**Environmental  
Planning  
Commission**

**Agenda Number: 2  
Project Number: 1003859  
Case #s: 11EPC-40067/40068 and  
04EPC-01845  
January 19, 2012**

**Staff Report**

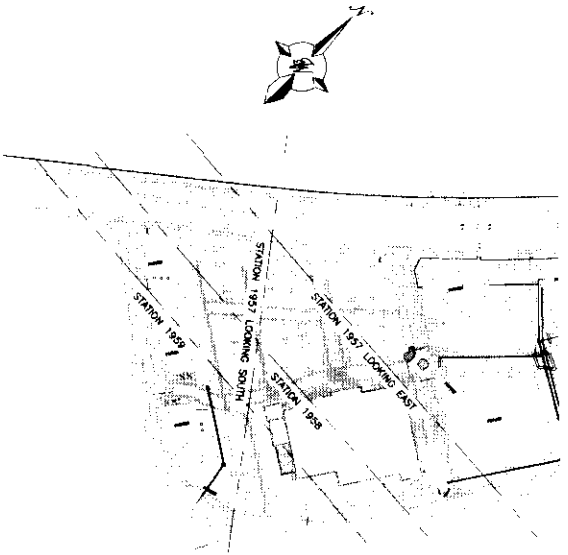
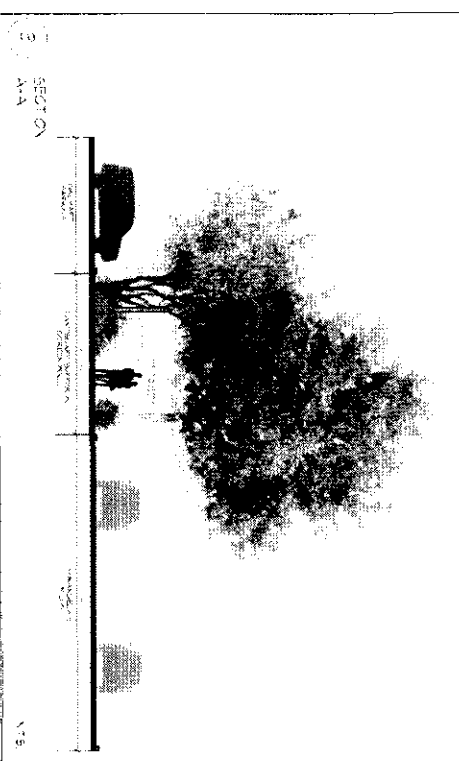
The applicant's view plane analysis is presented on Sheet C-5. Two view plane diagrams, A and B, are included. The view line for A runs from approx. 80 feet north of the corner of Coors Blvd. and Mirandela St. and intersects with the proposed building at a 30 foot height, between the garden center and the main

Note that the building heights used in view line A and view line B are interchanged; that is, *the 30 foot height corresponds to view line A and the 33 foot height corresponds to view line B* (see the site diagram on the right-hand side of Sheet C-5). Knowing this, Staff calculates the following (in feet):

Modeling results (the pictures) reveal that the proposed building would not penetrate the view line of the ridge of the Sandia Mountains, though the view plane exhibit (see Sheet C-5) also demonstrates this. Staff suggests showing view line A and view line B on the model results to make them more meaningful. Model results for station 1959 and station 1957 (looking east) do not correspond to the proposed building elevations because: the model should step up twice and not protrude on the right-hand side (station 1959) and a tower element should be shown (station 1957, looking east). The station 1957 (looking south) view line does not intersect the proposed building, so no modeled building should be shown as result.

The scale for the View Planes is 1"=50' and is shown on the lower right corner of Sheet C5.

The view plan lines shown on Sheet C6 with the superimposed building were added to demonstrate the view to the trees in the Bosque are not impeded, which was a concern raised in the facilitated meeting. This also demonstrates compliance with the Coors Corridor Plan (except for the middle massing element encroaches one foot more than allowed). This encroachment balances the Coors Corridor Plan requirements with the Large Retail Facility Elevations. These views were added in addition to the Coors Corridor view alignments shown on Sheet C5. We have added a short narrative to explain the purpose of the view plan pictures on Sheet C6.

① FRONT (WEST) ELEVATION

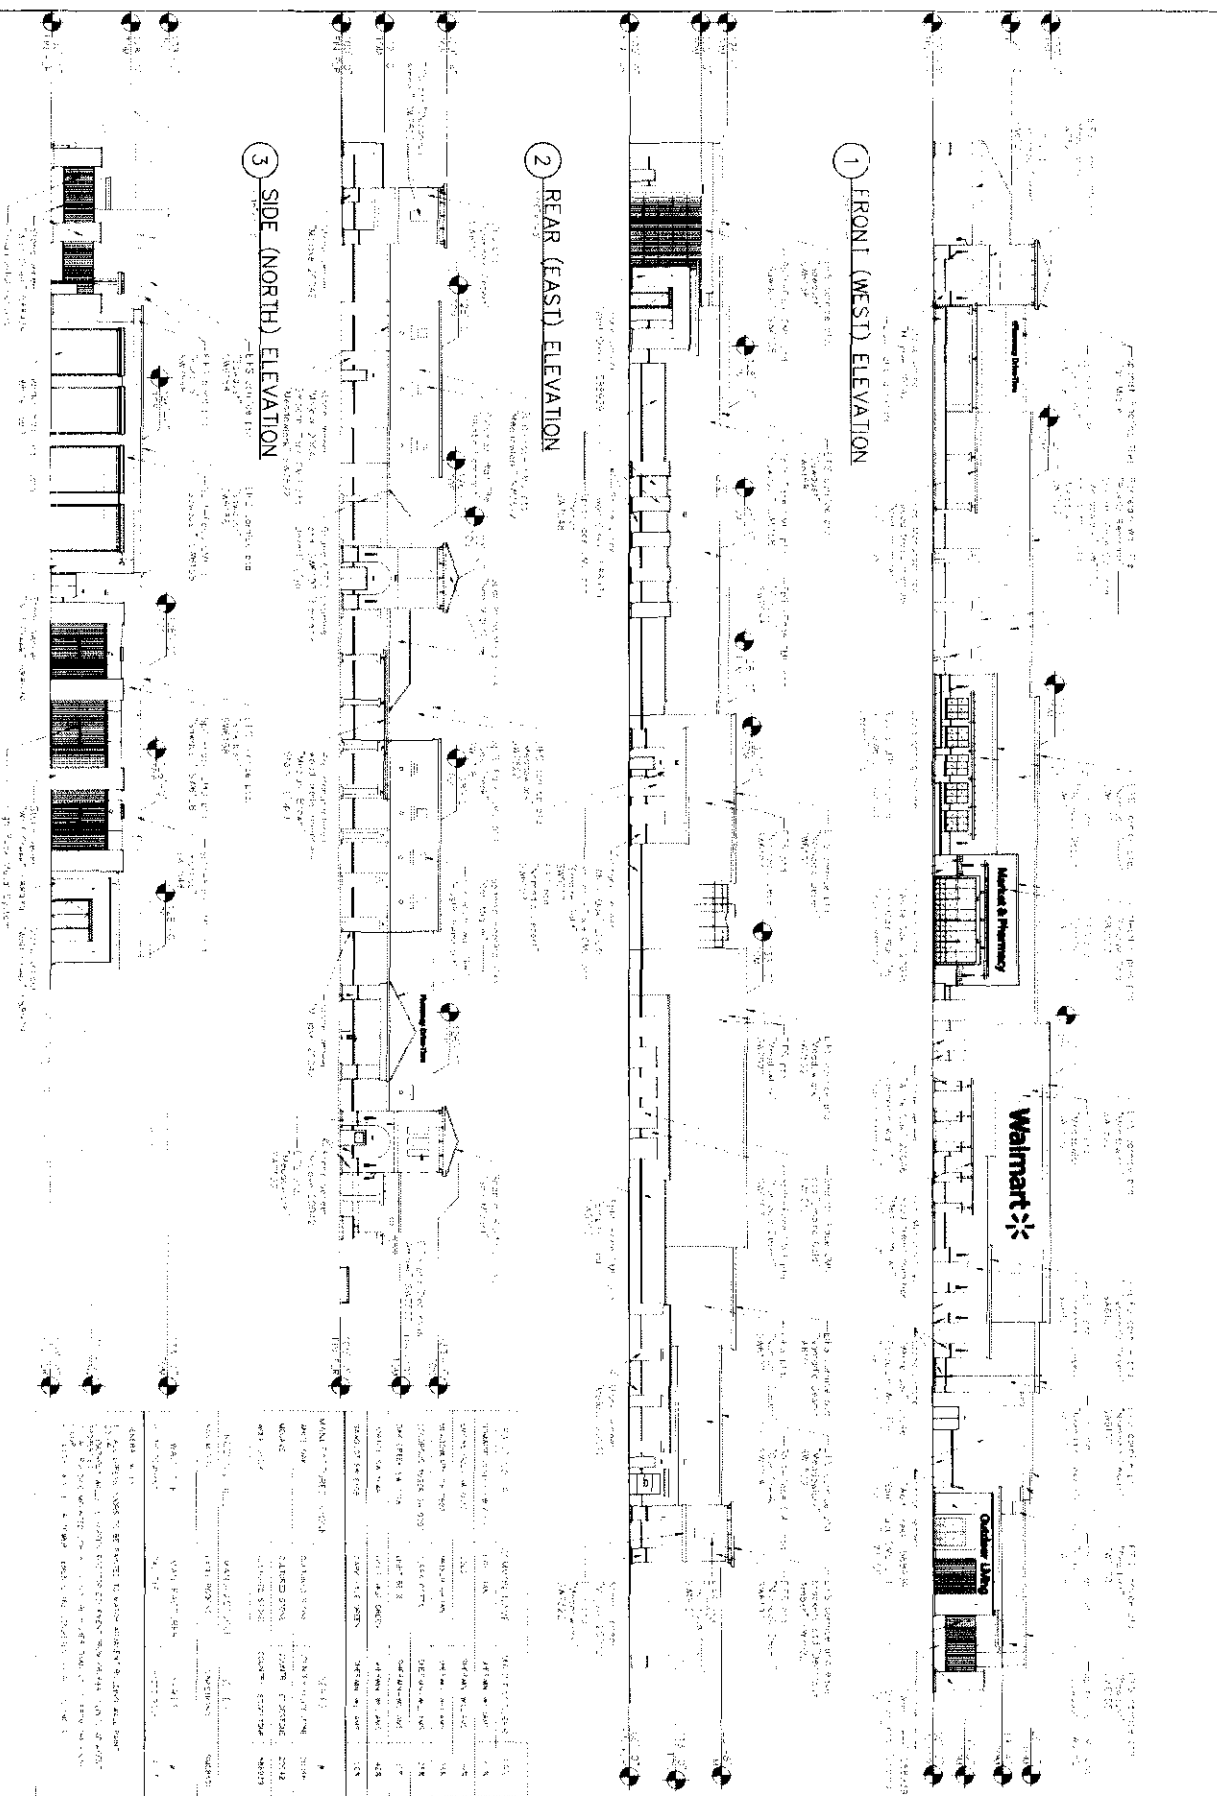
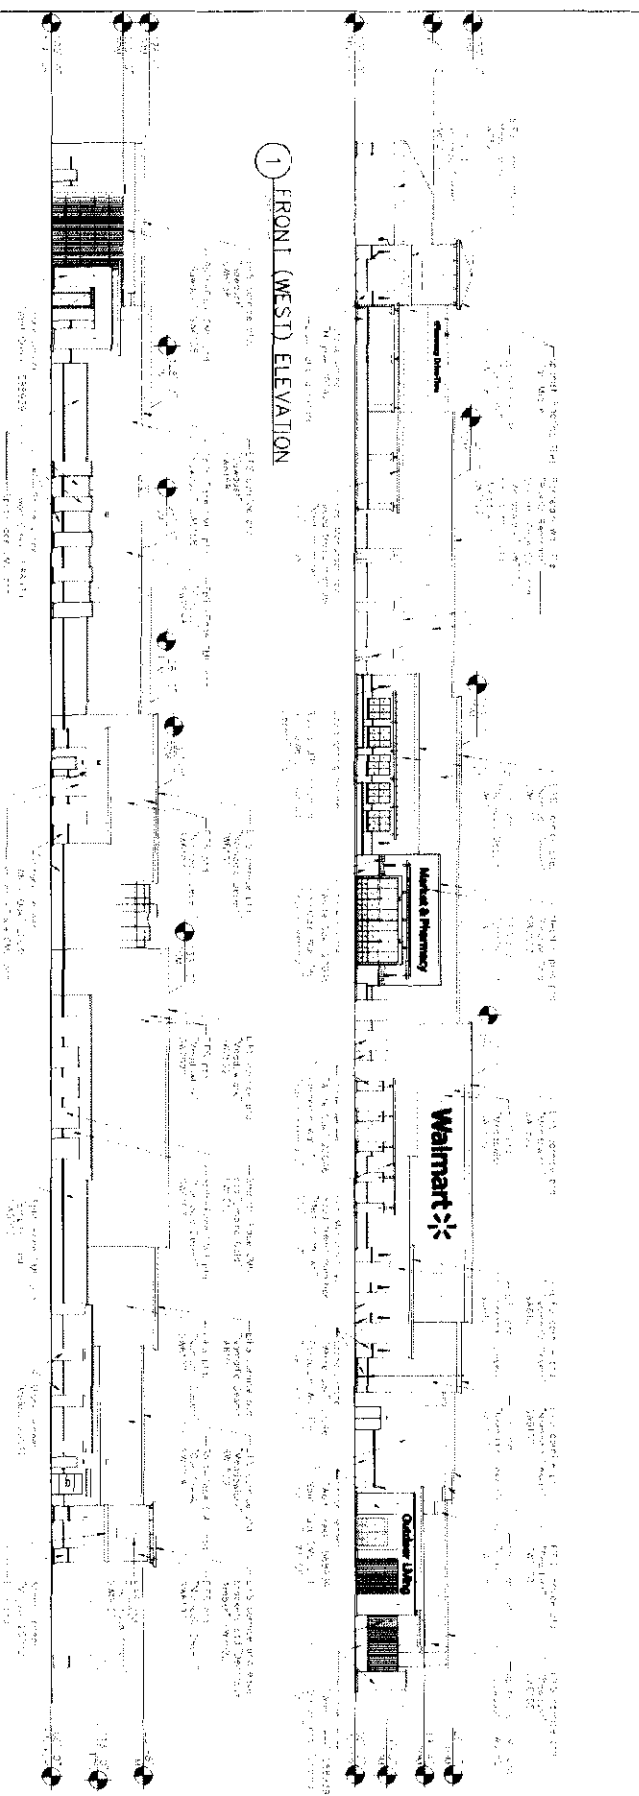
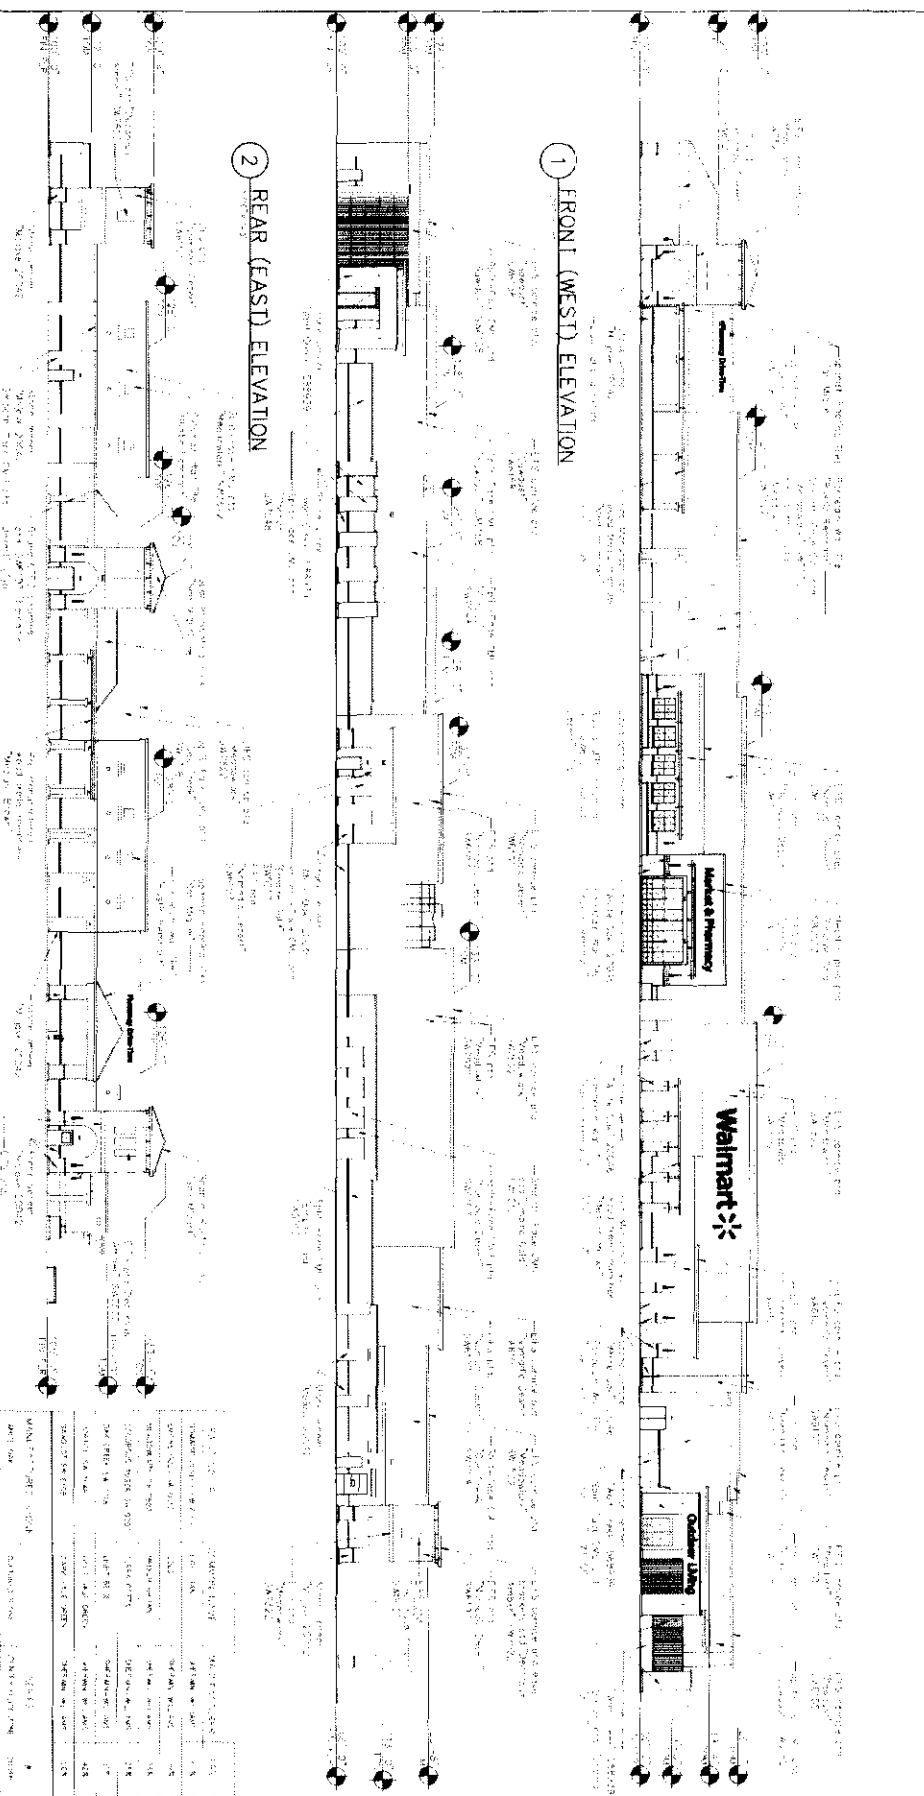
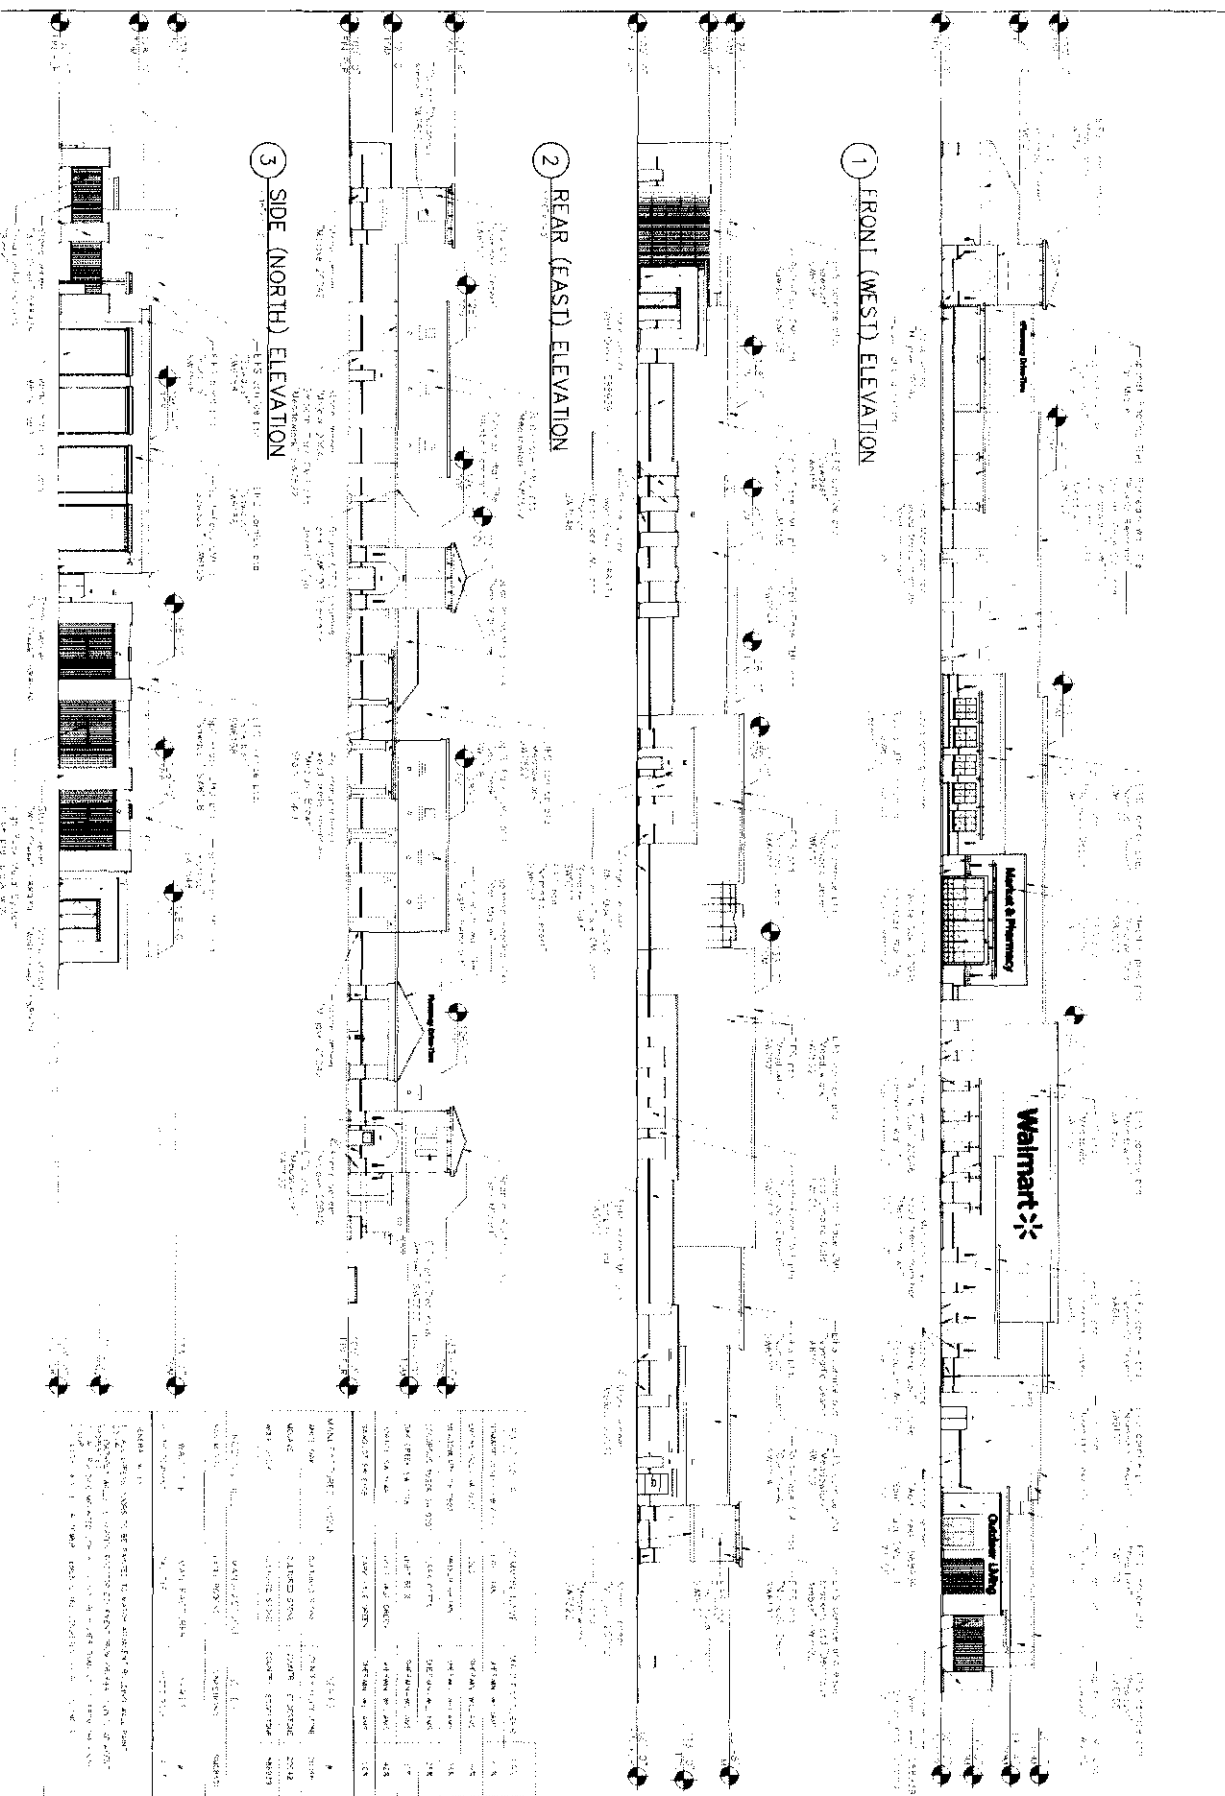
- A. As required by the North Andalucia at La Luz site development plan for subdivision, all sides of the building must be architecturally articulated with various elements from New Mexico architectural styles: Pueblo Revival, Pueblo and Spanish Colonial. Commercial buildings will be a hybrid of these styles (Design Standards, Sheet 3, Column 1). Include additional architectural elements to make the building reflect these styles to a greater degree.

- B. Finished building material shall be applied to all exterior sides and shall be consistent on all sides (Design Standards, Sheet 3, Column 1). All sides, including the rear side, must be consistent.
